Certificate of Appropriateness

3233 E Kenwood

Lake Park Garage and Stables, North Point North

LAKE PARK SERVICE BUILDING
3233 EAST KENWOOD BLVD, MILWAUKEE, WI

FURNACE CONCENTRIC KIT

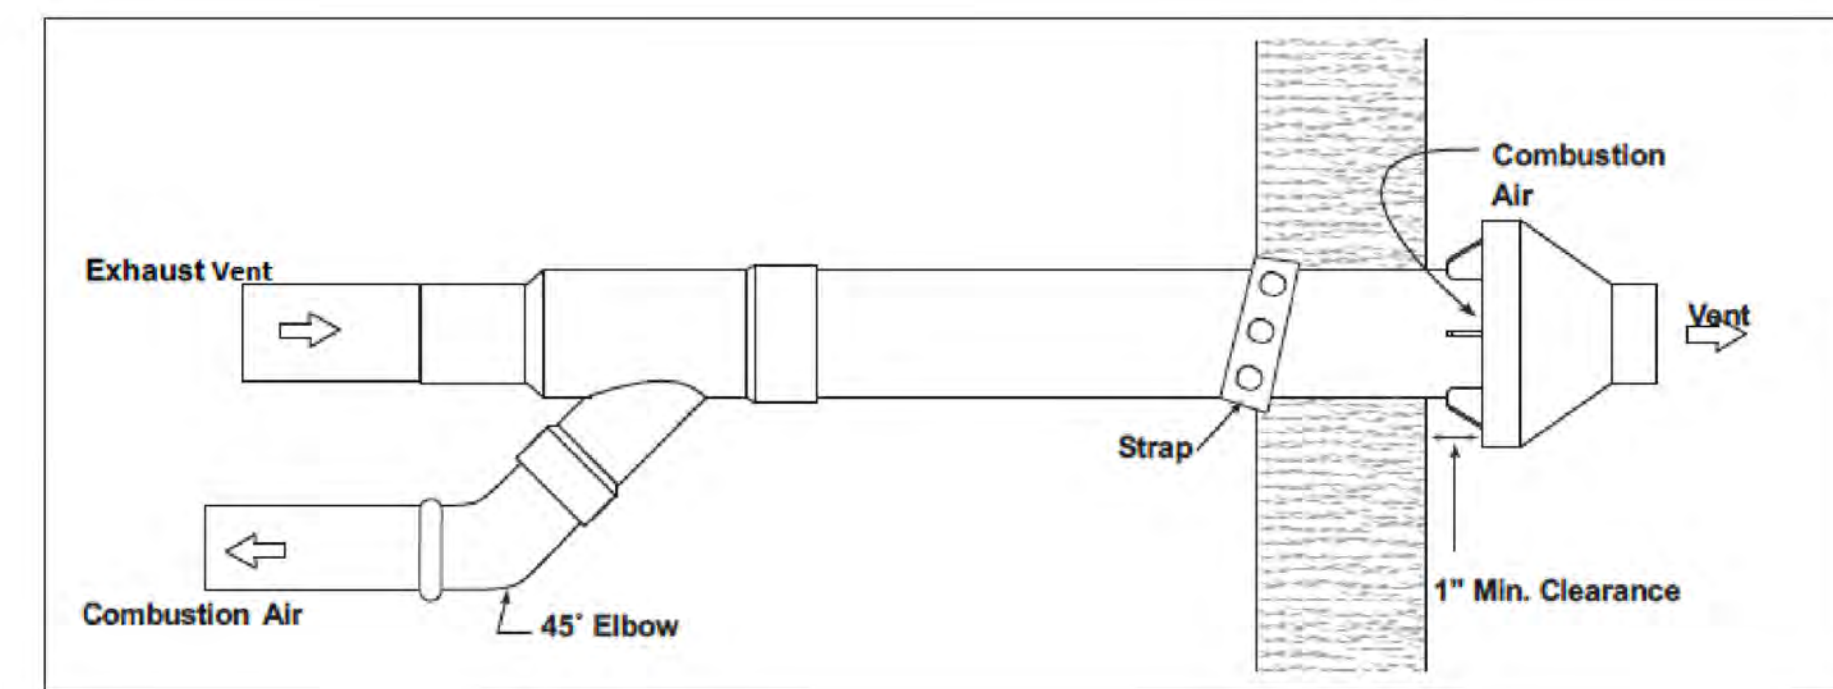
Concentric vents shall be installed through roof rather than walls and be black or painted to match roof shingle color

SHEET M-4

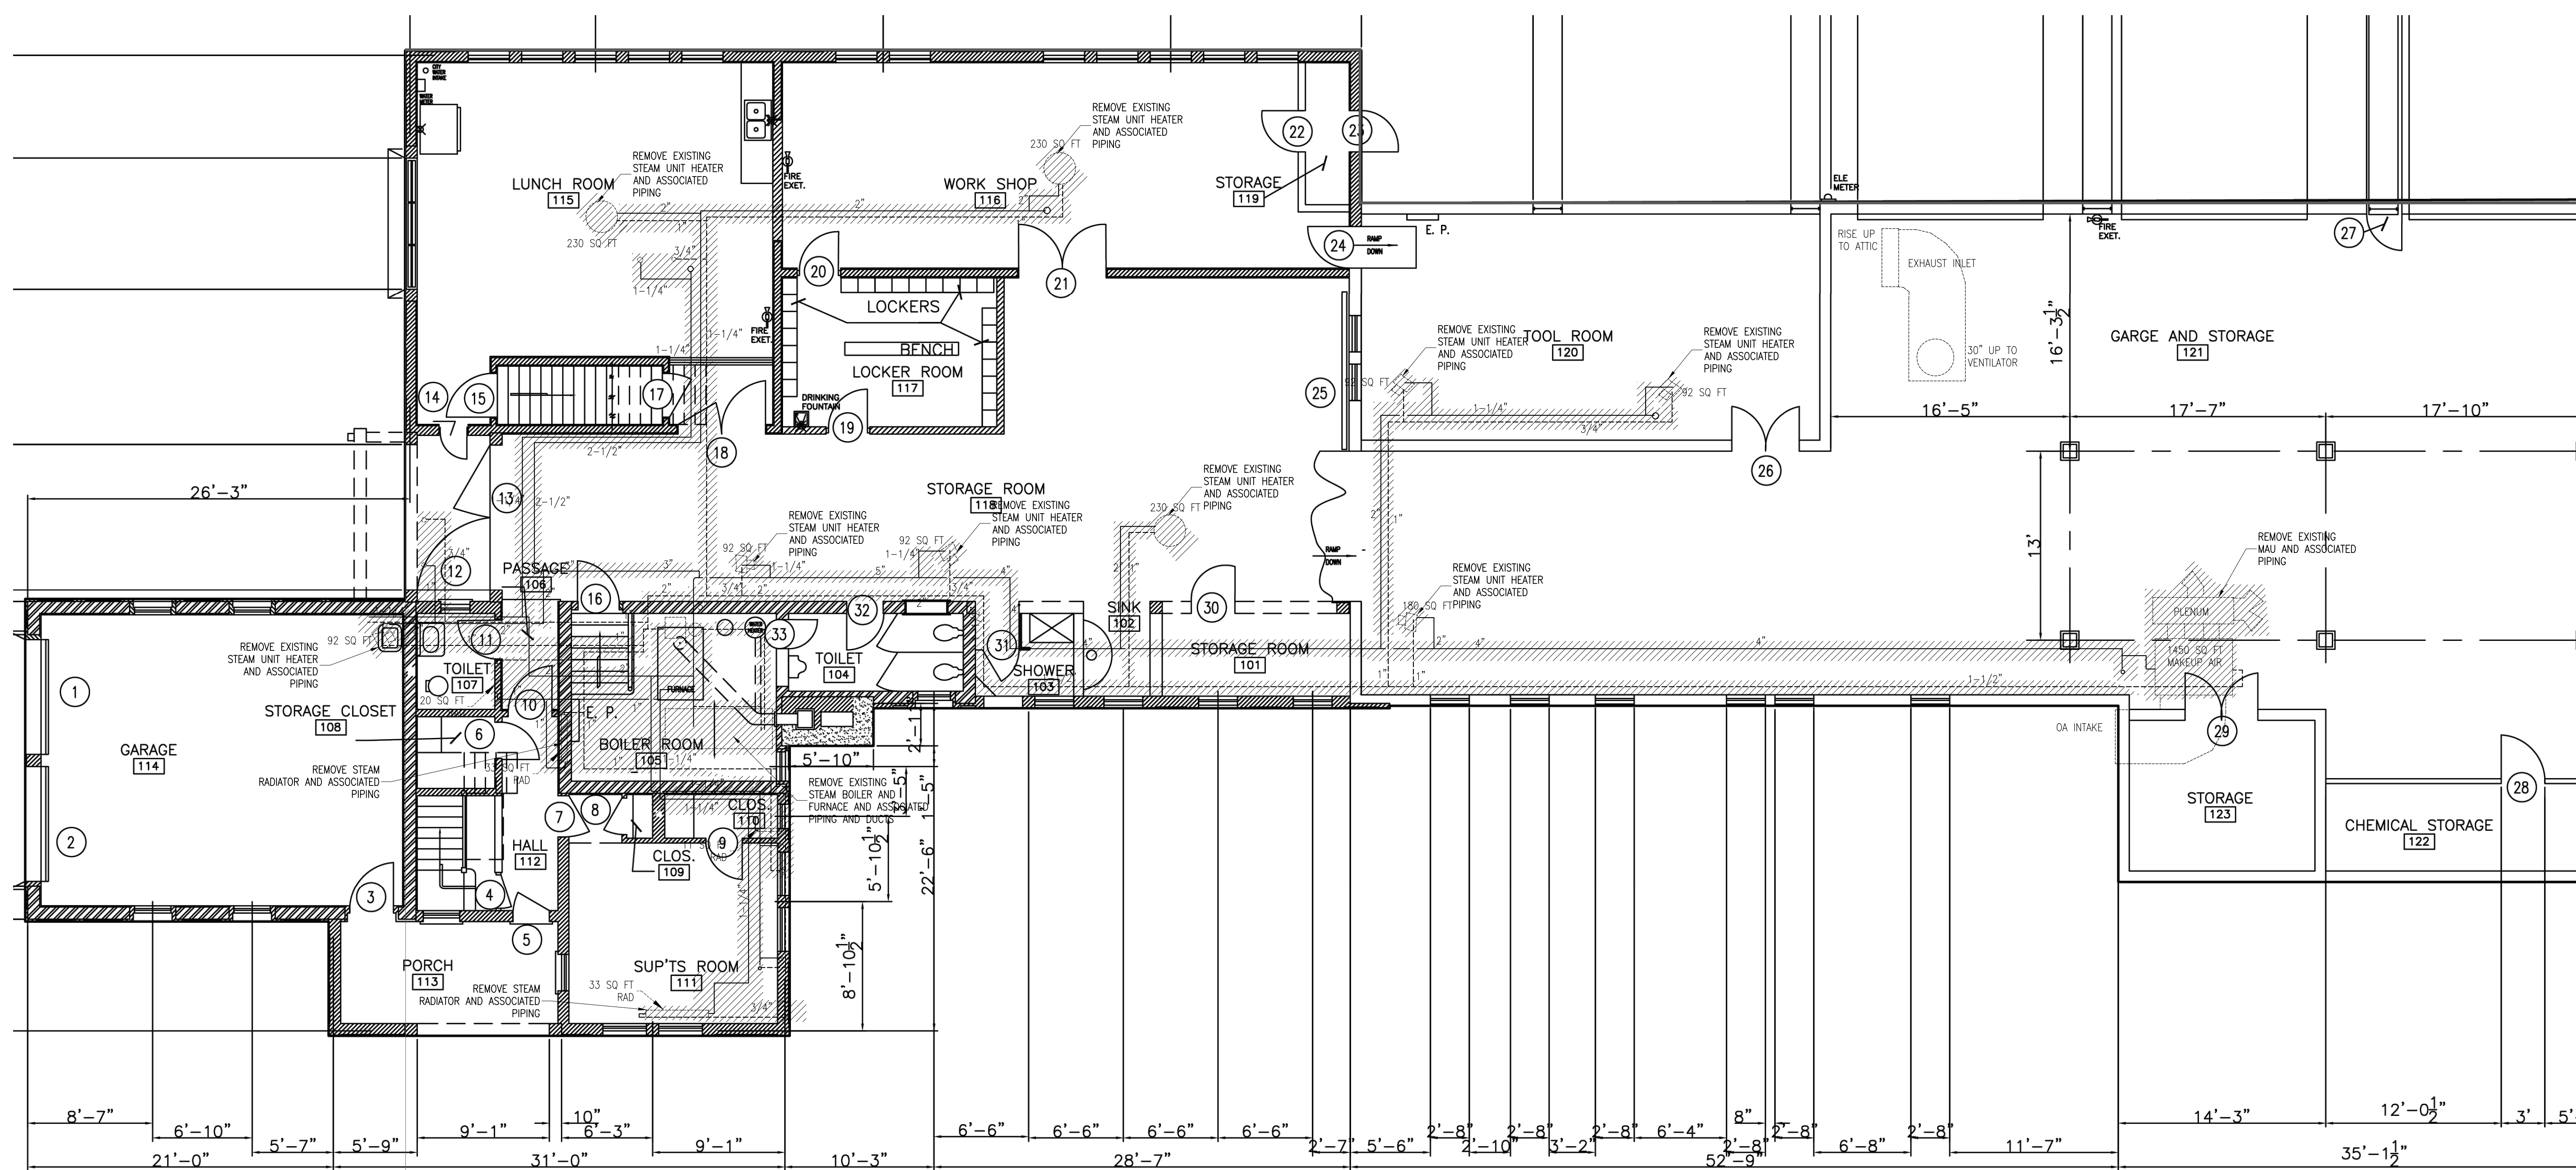
Install HVAC equipment as shown, except that concentric vents through stucco gable ends are prohibited. All concentric vents must be routed through the roof and be black. Fresh air intake vents shall be painted to match surrounding materials.
